DHCD, DBFR 2006 Code Change Process April 9, 2007 Stakeholder's Meeting Agenda Package

Subject: Code Change Meetings for the 2006 Regulations

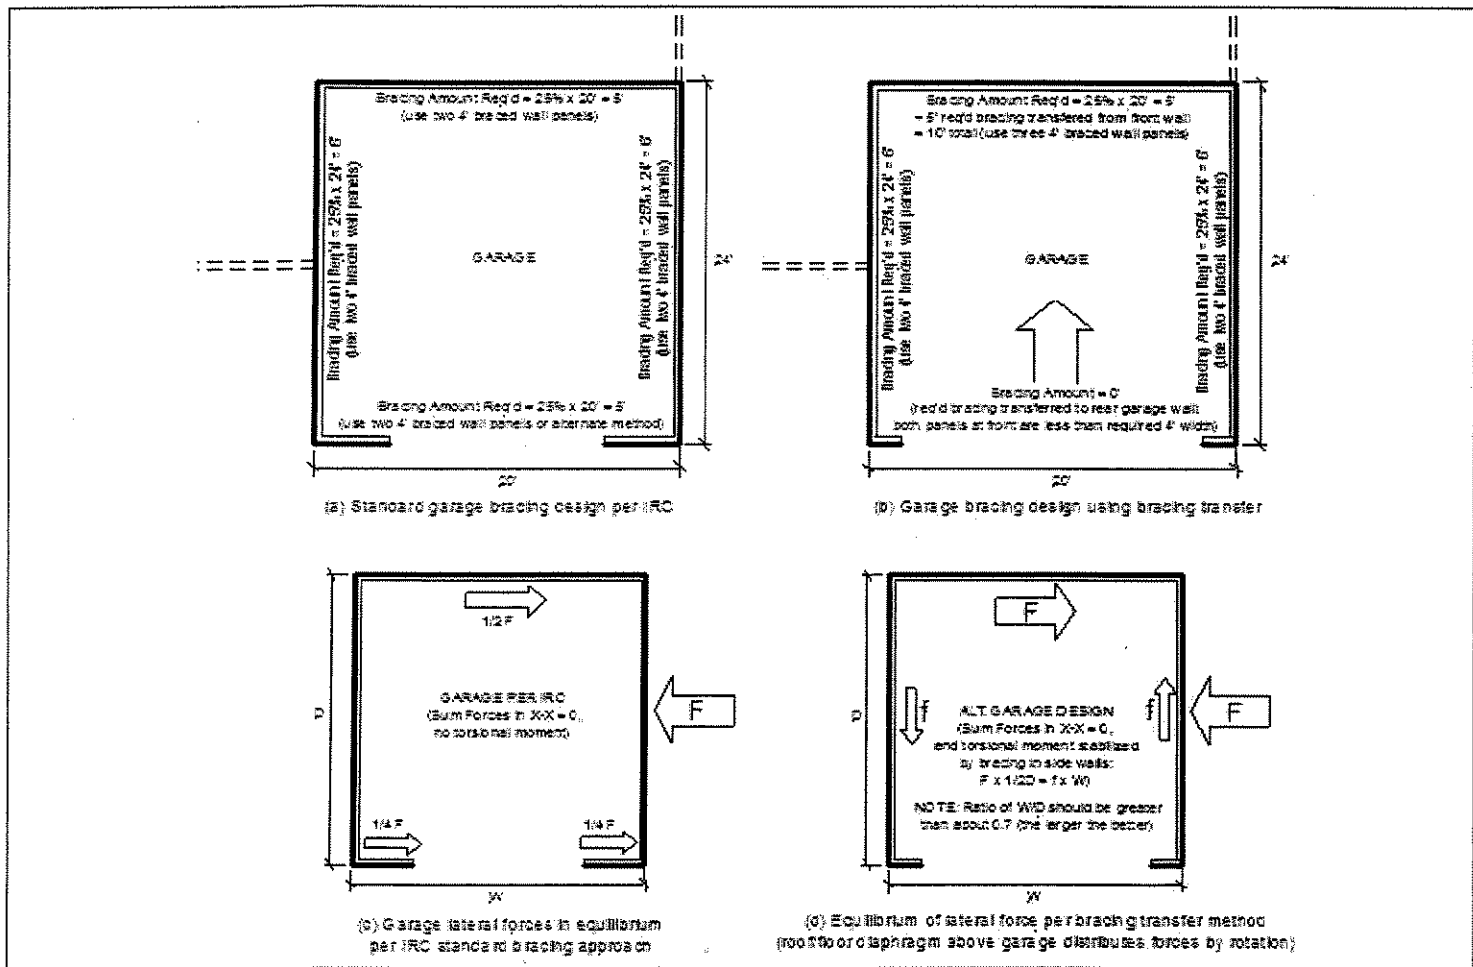
The second exception (see also the Figure below for example) provides a means of bracing a garage as a structural unit and does not require bracing on the garage opening wall line. This requires that the bracing amount is effectively doubled on the rear garage wall (opposite from the garage opening) to provide equivalent resistance to the direct shear load. Because this arrangement creates a torsional loading condition, the side walls must also be adequately braced to resist the torsional or twisting load that is created by way of a "force couple". This is simply achieved by bracing both side walls in compliance with bracing requirements of Section R602.10.1 and by limiting the plan aspect ratio of the garage (depth to width) as described in the proposal. This method is not new and has been in use for some time, but only by way of an engineered solution for individual buildings. Because of its simplicity and common need/use, this approach is more effectively addressed as a prescriptive solution in the code. This exception does not reduce bracing strength but achieves compliance through a different approach to building stability and lateral load analysis that more accurately distributes lateral load based on relative resistance of shear walls through floor and roof systems that act as rigid diaphragms based on whole building testing. The approach is explained and illustrated below.

Consider a garage of width, W, and Depth, D with a garage opening located in the width direction (see Figure below). The lateral load acting parallel to the garage opening and rear walls is resisted directly by wall bracing in the rear garage wall only (bracing value of narrow walls to either side of garage opening is considered negligible). This realistic loading condition creates a force couple or moment that attempts to rotate the garage opening wall about the rear wall that contains all of the shear resistance (bracing). The magnitude of this force couple is $V \times \frac{1}{2} D$ where V is the lateral load force (and is equivalent also to the amount of load resistance required in the way of wall bracing). While the direct shear force is resisted by the rear garage wall, the force couple is resisted by the side walls which produce a resisting force couple with a magnitude of $V_{sw} \times W$. Therefore, to maintain equilibrium of forces $V_{sw} \times W$ must equal or exceed $V \times \frac{1}{2} D$, where V_{sw} is the bracing resistance provide by the garage sidewalls. Setting these equal and solving for V_{sw} (required shear resistance in the side walls to resist the load force couple), the following design equation is determined to check equilibrium against the force couple or torsional moment created by this condition:

As shown above, when D/W is approximately 1.2 or less, this proposal that permits transfer of bracing from the garage opening wall to the rear garage wall (effectively doubling bracing amount in the rear garage wall) results in a structurally stable building or garage provided side walls area also braced in accordance with the code.

| <p>Proposed Change:</p> <p><i>Add a new Section R602.10.1.2 to USBC (following IRC 2006 format) and revise subsequent section numbering as follows:</i></p> <p><u>R602.10.1.2 Braced wall lines containing garage door openings.</u> Walls of attached or detached garages shall be braced in accordance with Section R602.10.1. Where wall segments to either side of a garage opening are too narrow to permit use of bracing methods in Section R602.10.3, the wall line containing the garage opening shall be braced in accordance with Section R602.10.5, R602.10.6, or other approved method.</p> <p><u>Exceptions:</u> One of the following exceptions shall be permitted to apply to garage opening wall bracing for attached or detached garages in Seismic Design Categories A-C and where wind speeds are 100 mph or less.</p> <ol style="list-style-type: none"> 1. <u>When a garage opening wall of an attached garage is a part of a braced wall line that extends along an attached building, such braced wall line shall contain the amount of bracing required by Section R602.10.1 and one of the braced wall panels required to begin within 12.5 feet of each end of the braced wall line shall be permitted to begin no more than 21 feet from the end of the braced wall line containing the garage opening.</u> 2. <u>If a garage opening wall of an attached or detached garage is considered as a separate braced wall line and the width of the garage (measured parallel to the garage opening wall) is at least 0.8 times the depth of the garage, then no bracing shall be required on the garage opening wall line provided the amount of bracing in the rear garage wall line (opposite and parallel to the garage opening) is increased by the amount of bracing that originally would have been required within the garage opening wall line. Amount of bracing in and spacing of wall lines comprising the garage side walls (perpendicular to the garage opening wall line) shall comply with Section R602.10.1 and R602.10.1.1.</u> | | |
